Re: Augmented SVE Trench Completion Report for Attachment Z-1 Remedy  
Consent Decree, Civil Action No. IP 83-1419-C-M/S  
Envirochem Site, Zionsville, Indiana

**AUGMENTED SVE TRENCH  
COMPLETION REPORT  
FOR  
ATTACHMENT Z-1 REMEDY**

**ENVIRO-CHEM SUPERFUND SITE  
ATTACHMENT Z-1 REMEDY  
985 SOUTH U.S. HIGHWAY 421  
ZIONSVILLE, INDIANA**

April 30, 2009

**AS-BUILT CONDITIONS  
AUGMENTED SVE SYSTEM PIPELINE  
ALIGNMENT AND CONNECTION AT  
TREATMENT BUILDING**

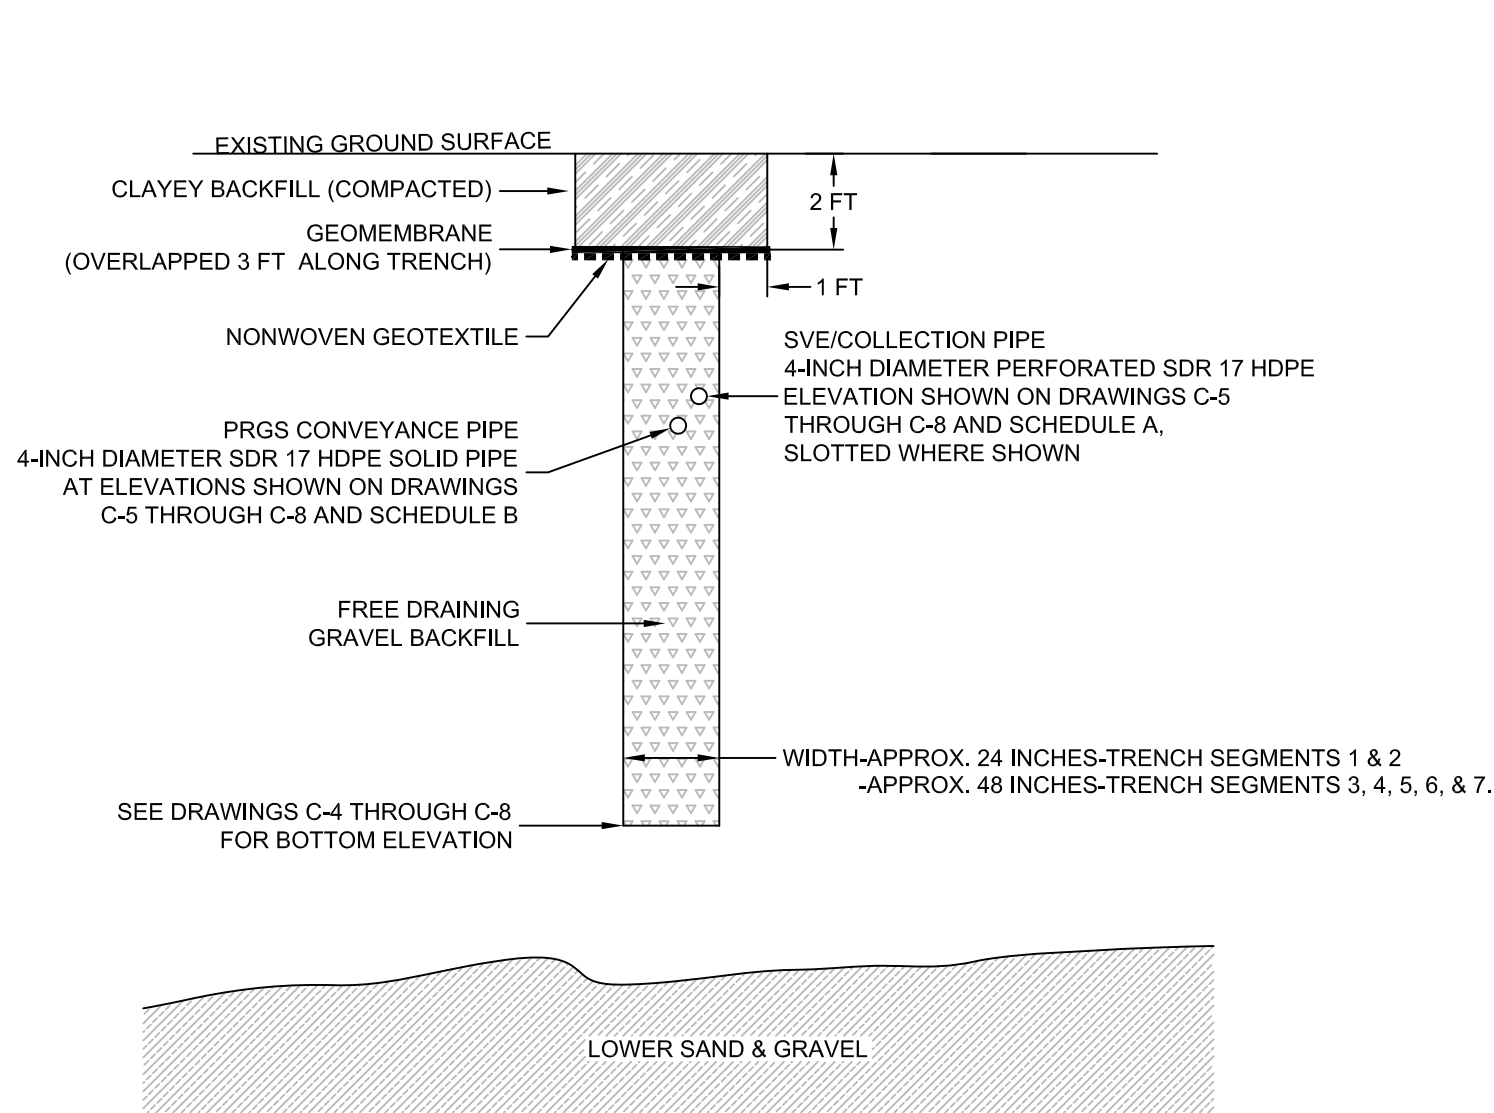
- Comment 5: See Section 1.2.5.8, page 9.
- Comment 6: Section numbering after Section 1.2 corrected as noted.
- Comment 7: See Section 1.3.9, page 11.
- Comment 8: See revised Figure C-9.

**AS-BUILT CONDITIONS  
AUGMENTED SVE DEWATERING SYSTEM  
PIPELINE ALIGNMENT**

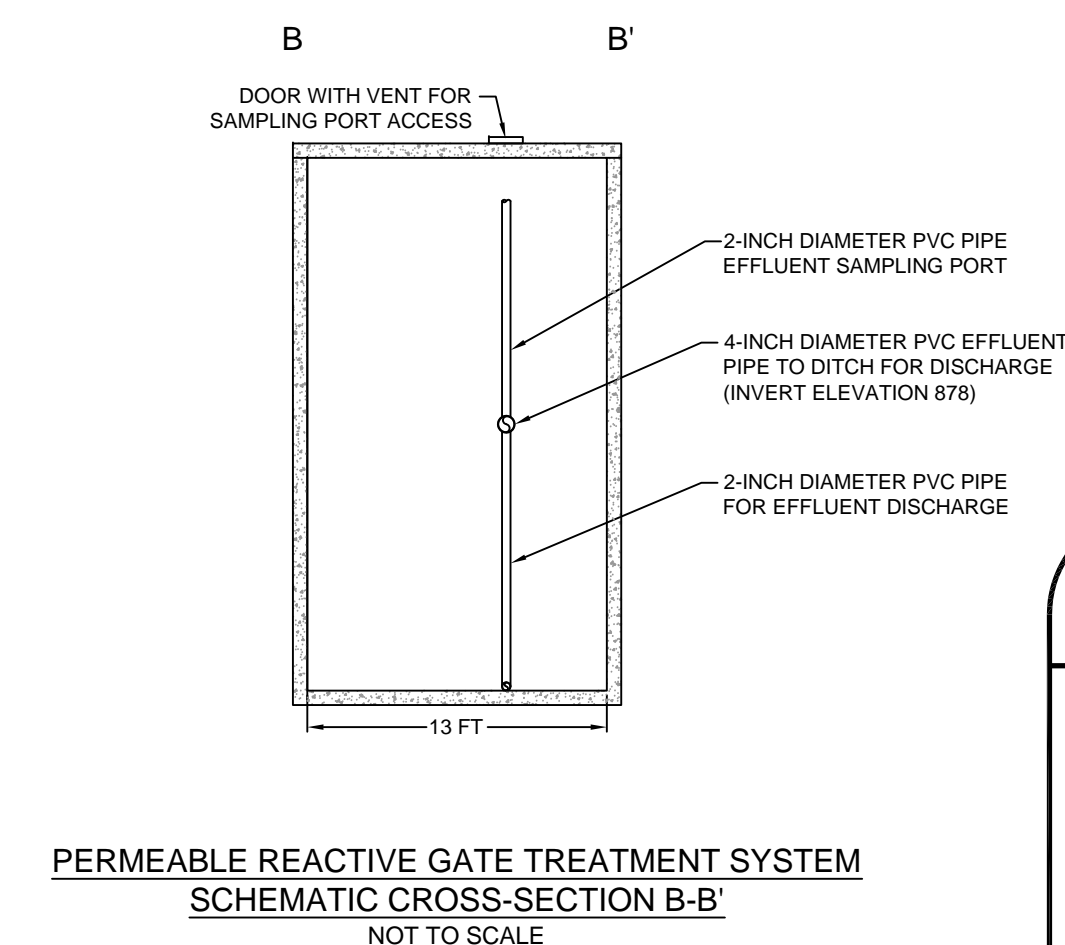
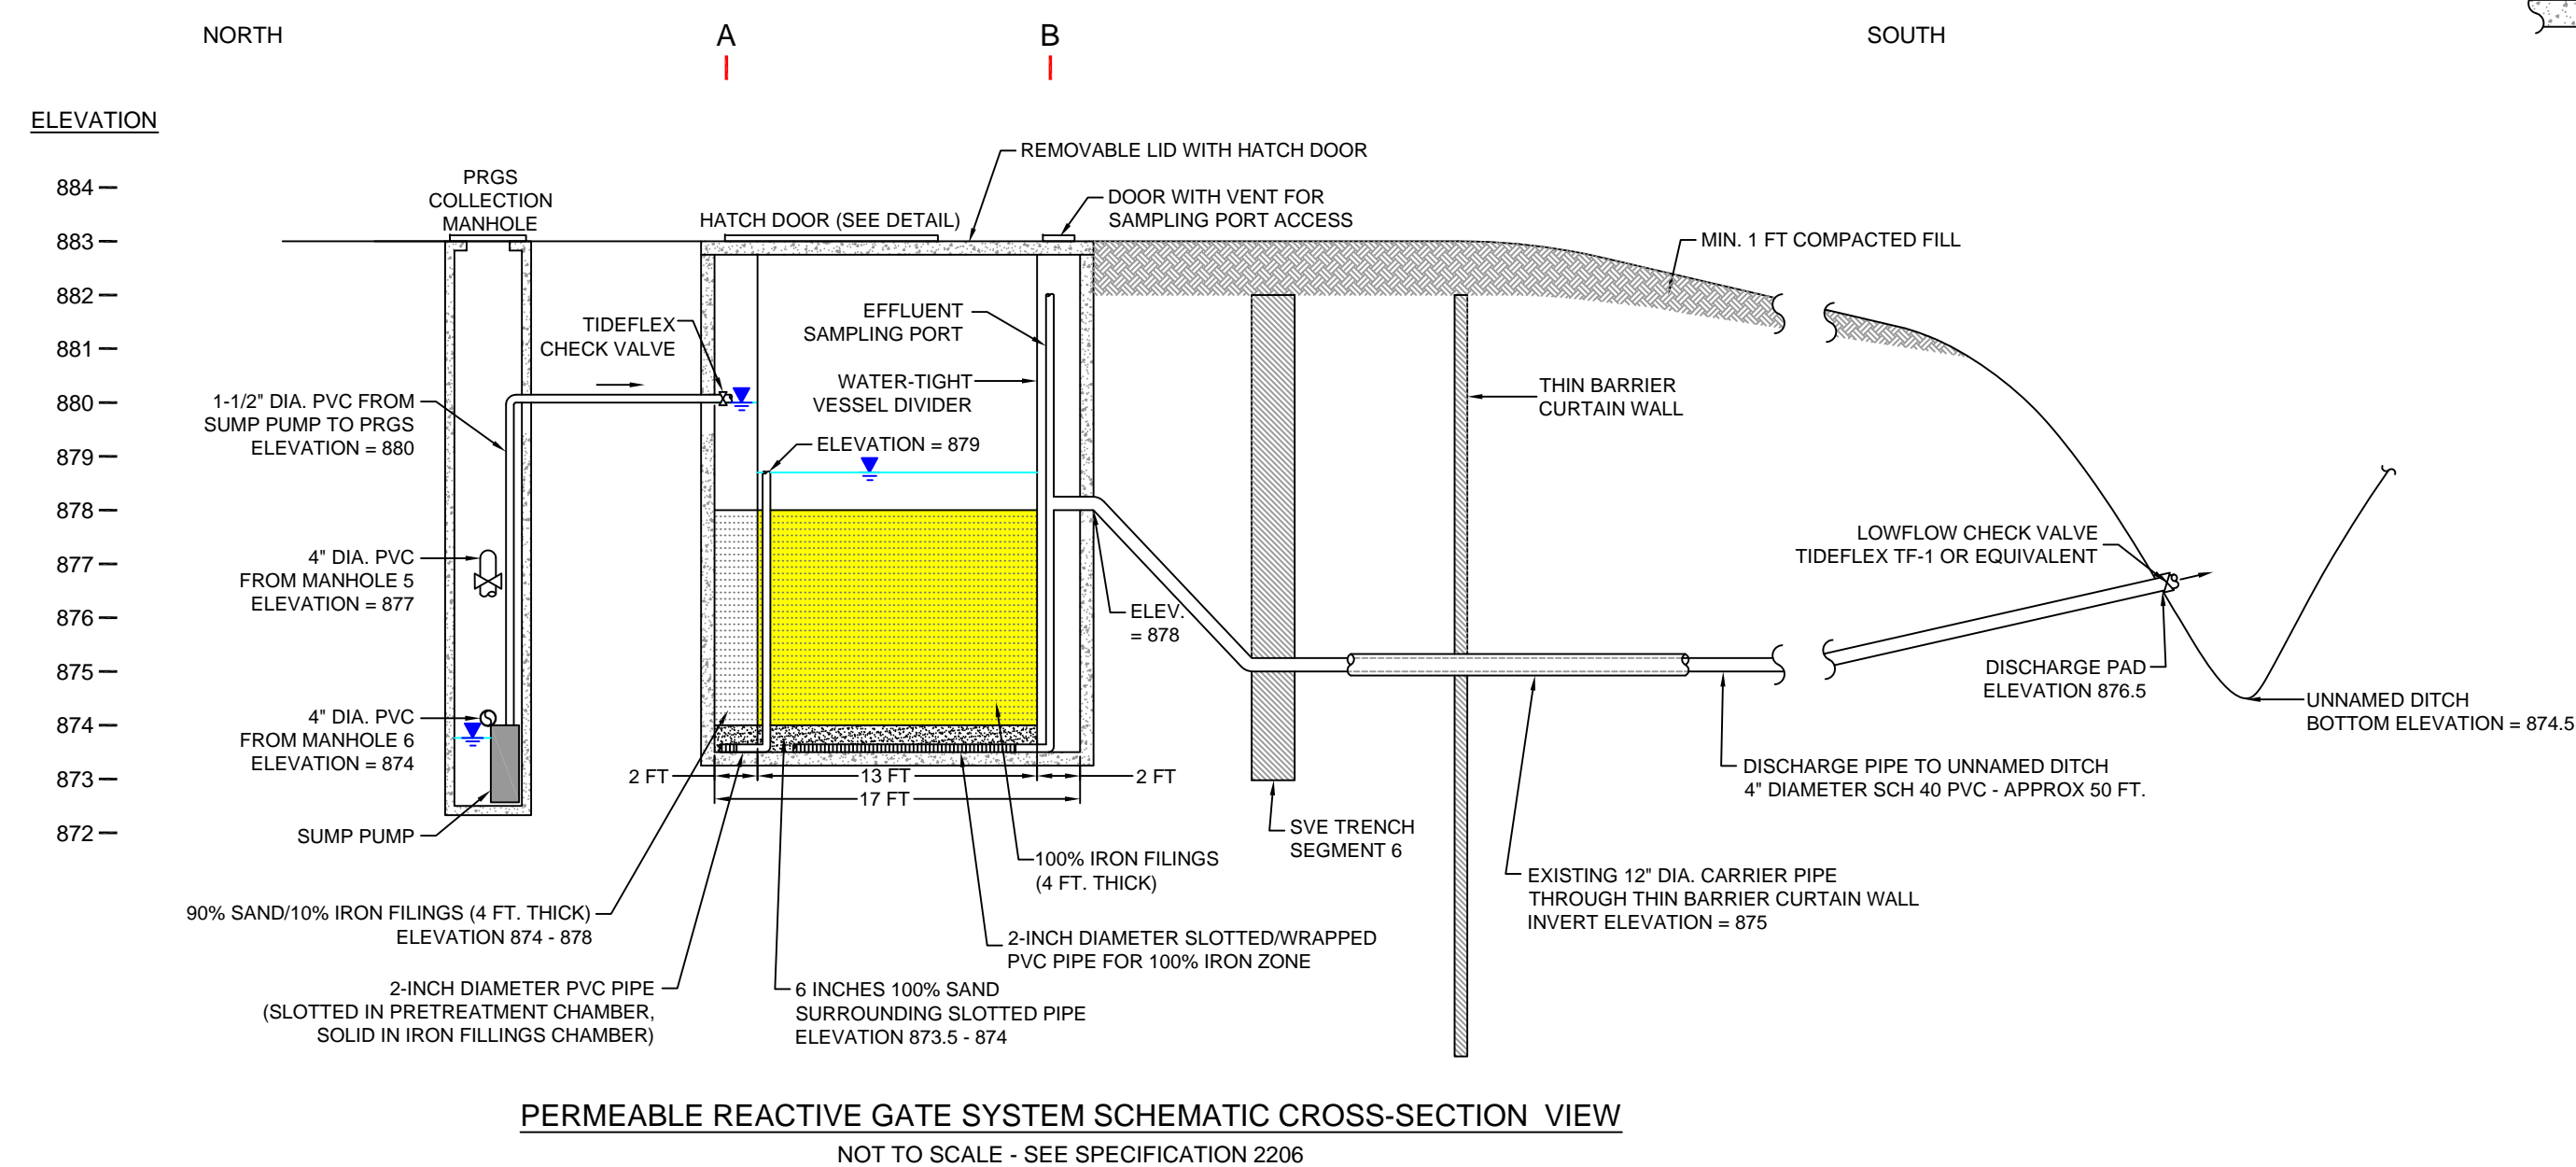
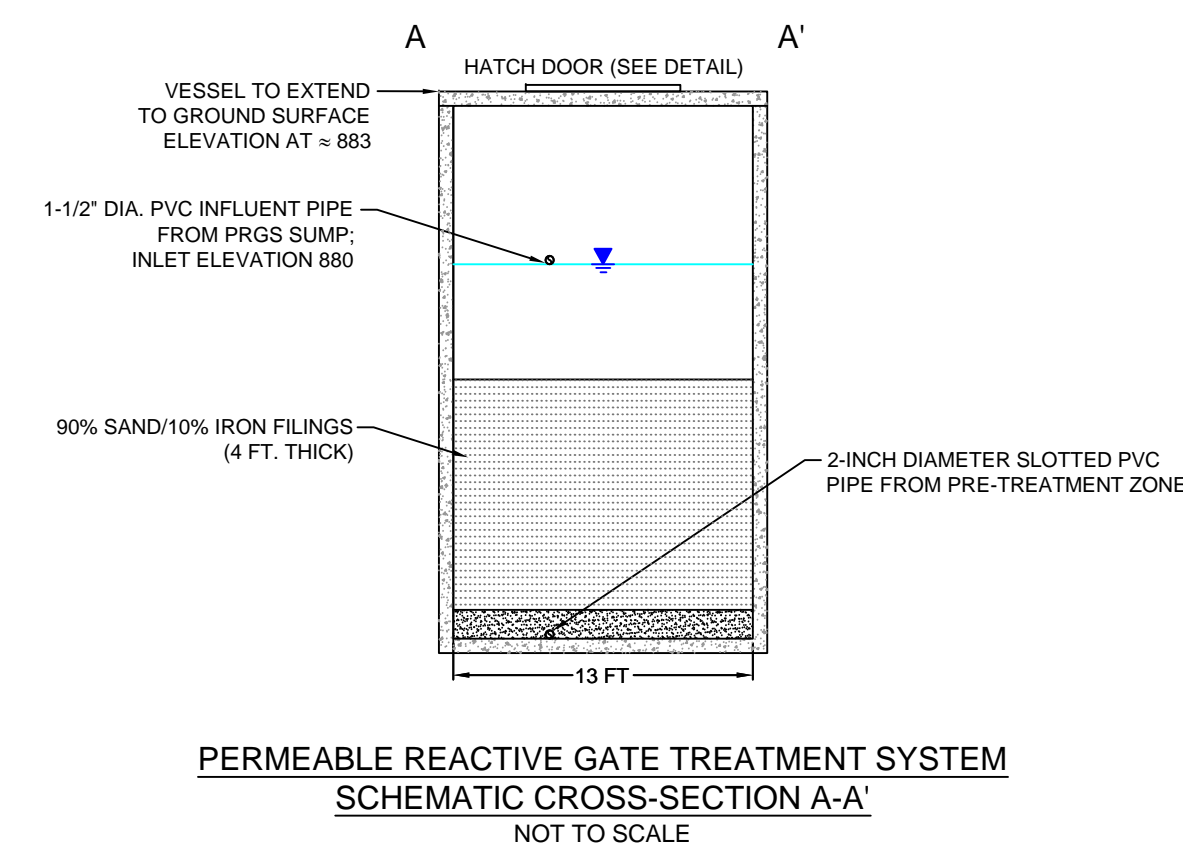
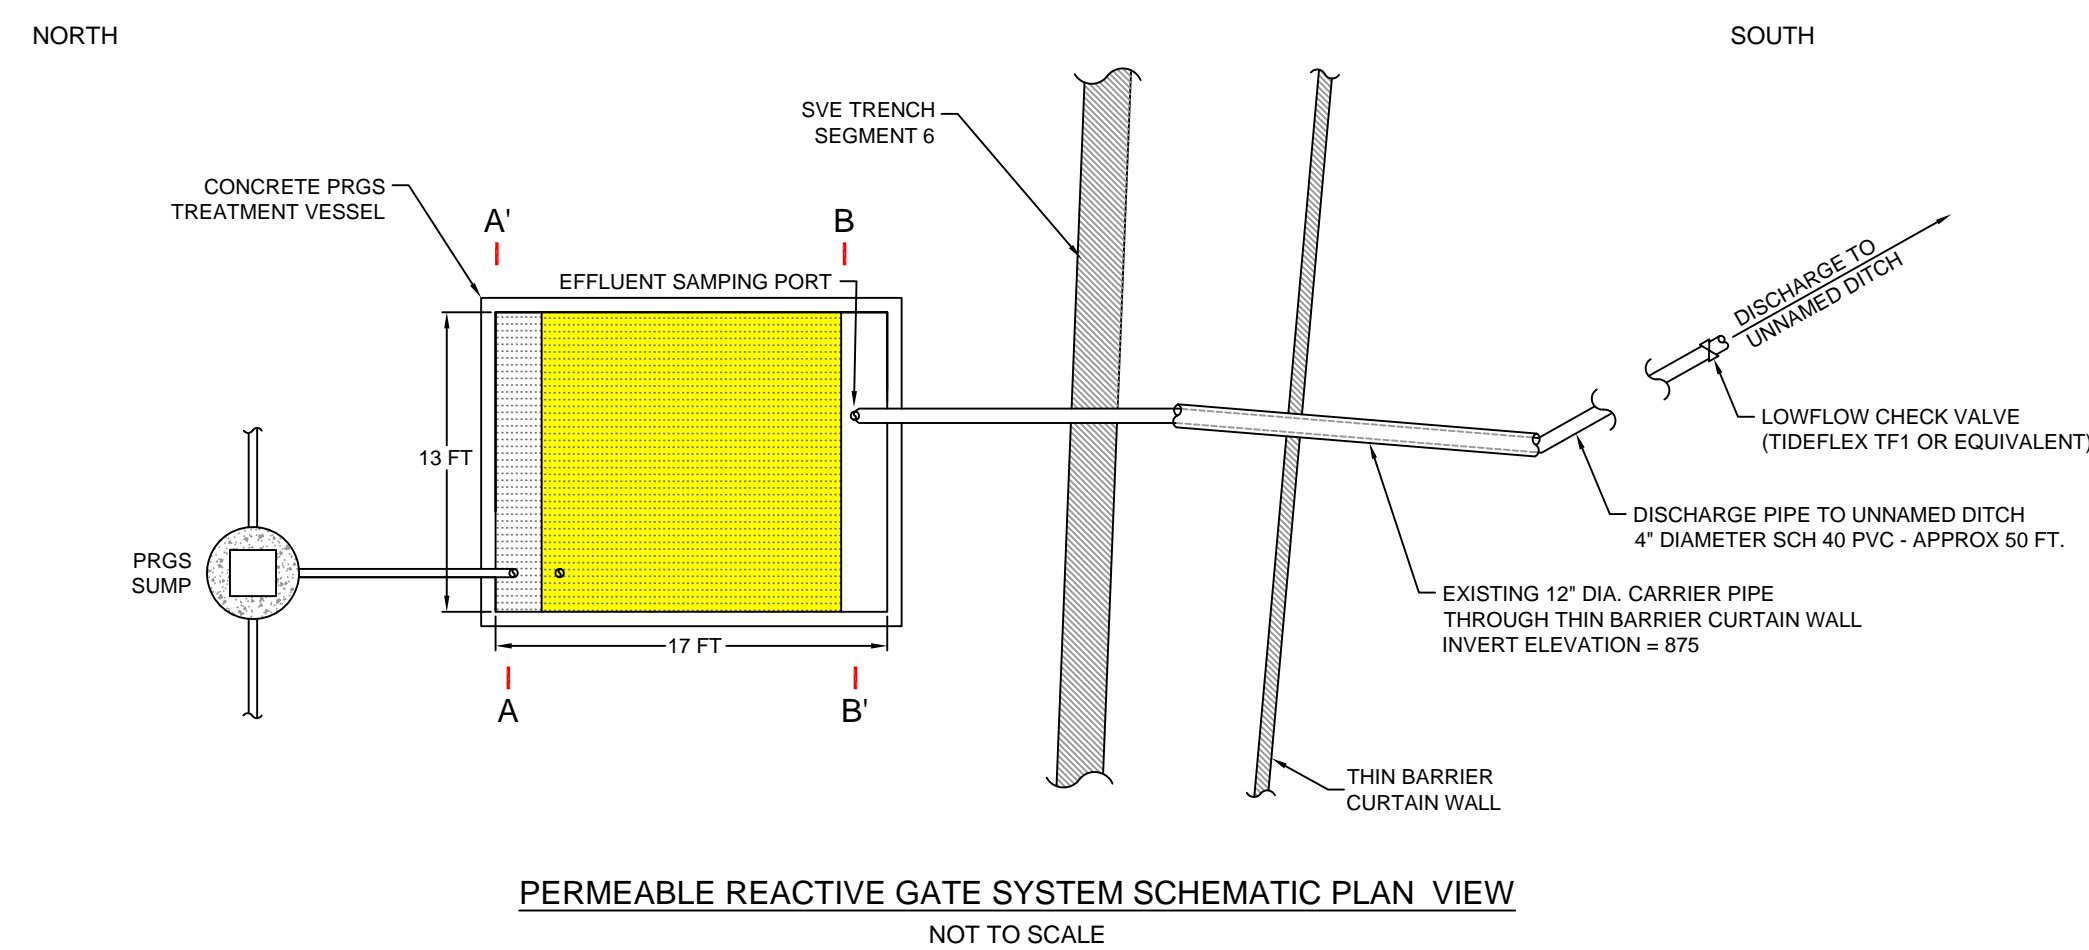
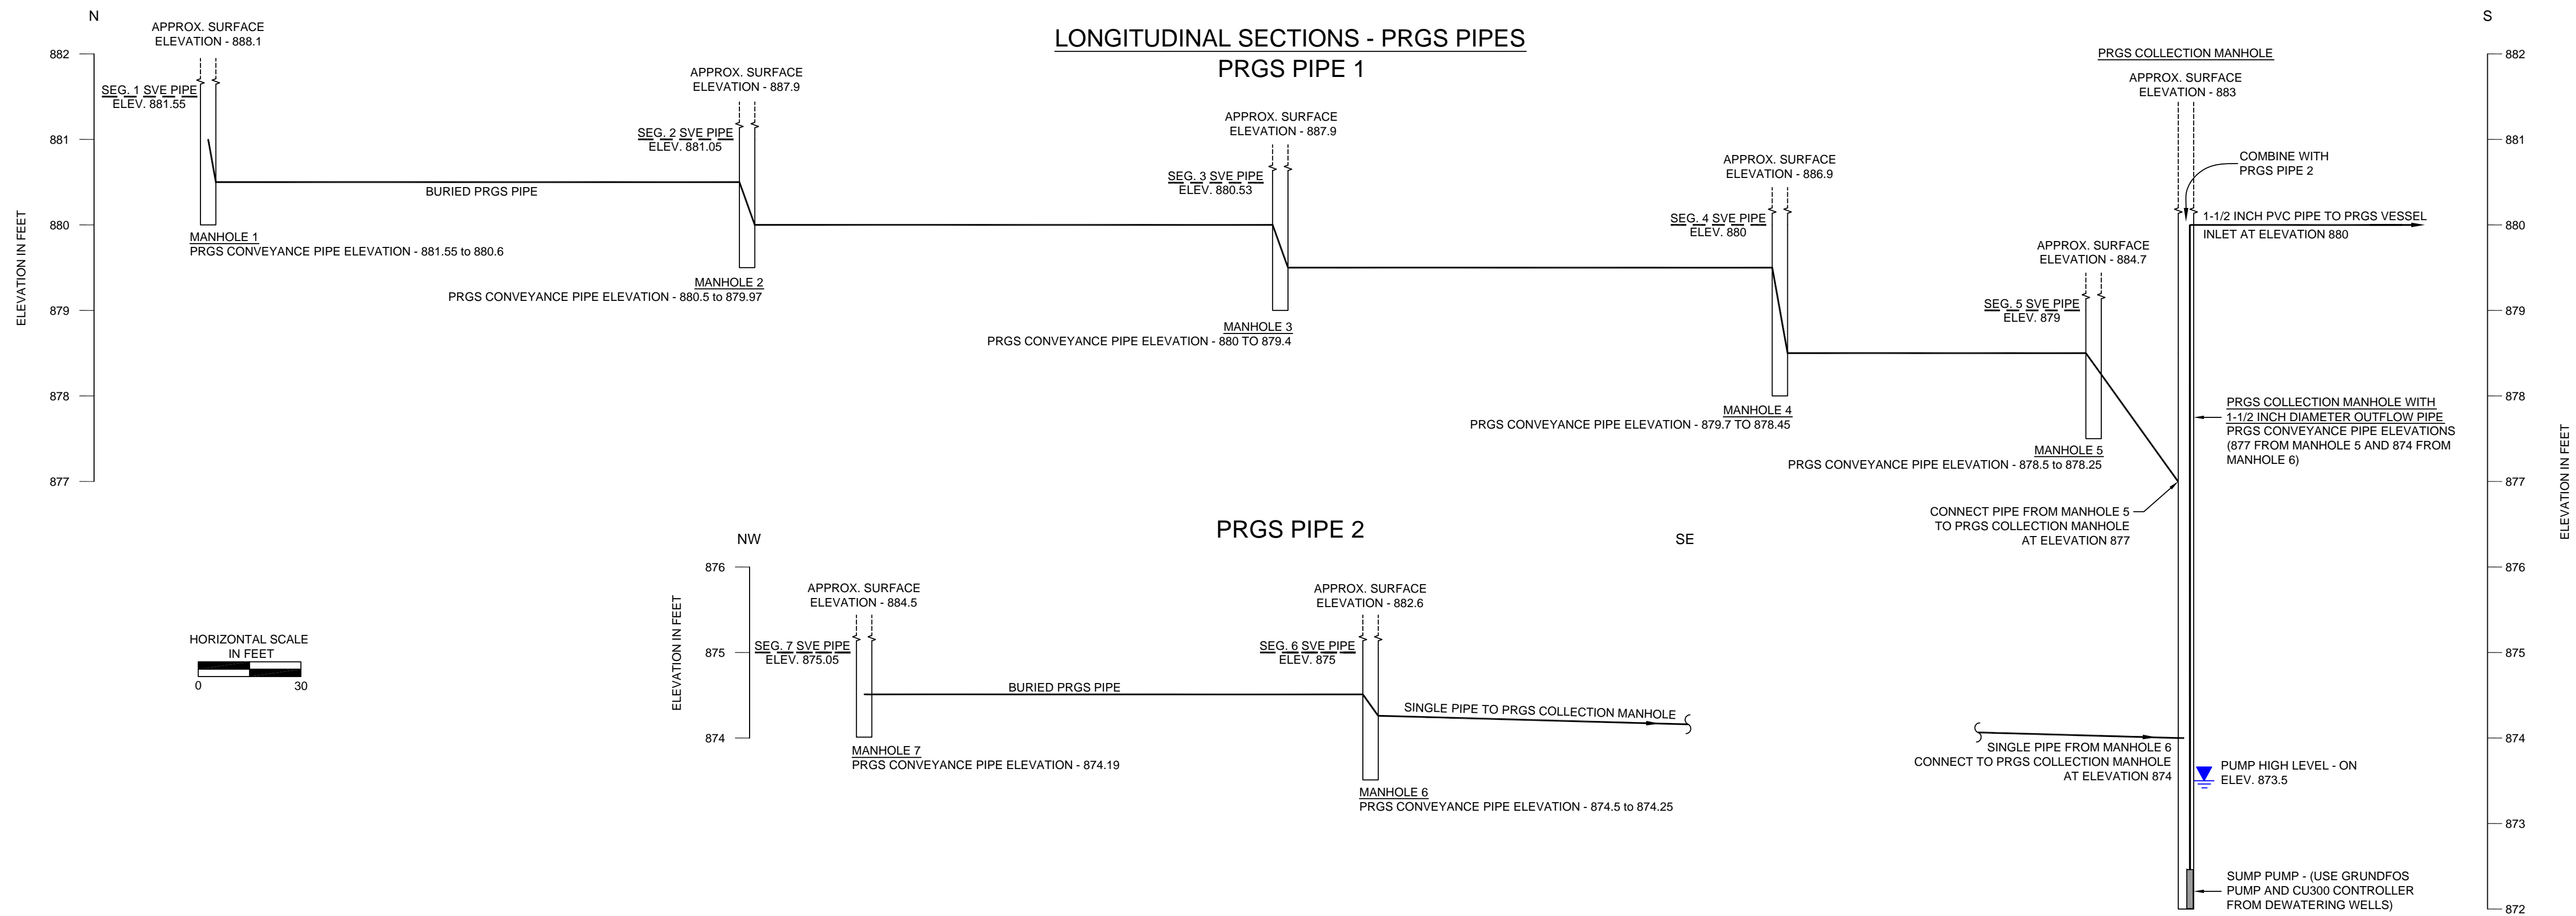
- Comment 9: See revised Figure C-11.
- Comment 10: In response to comment No. 10, please note that the 1987 ROD was for a combined remedy for ECC and Northside Landfill, which was subsequently changed to an SVE remedy for ECC alone in the ROD Amendment of 1991. A separate remedy was selected for Northside Landfill. The ECC remedy was subsequently modified to the 1997 Revised Exhibit A remedy which included excavation of the southern concrete pad area and dual level SVE in the central and northern portions of the site. In 2001, it was concluded that the Revised Exhibit A remedy as constructed would not achieve compliance.
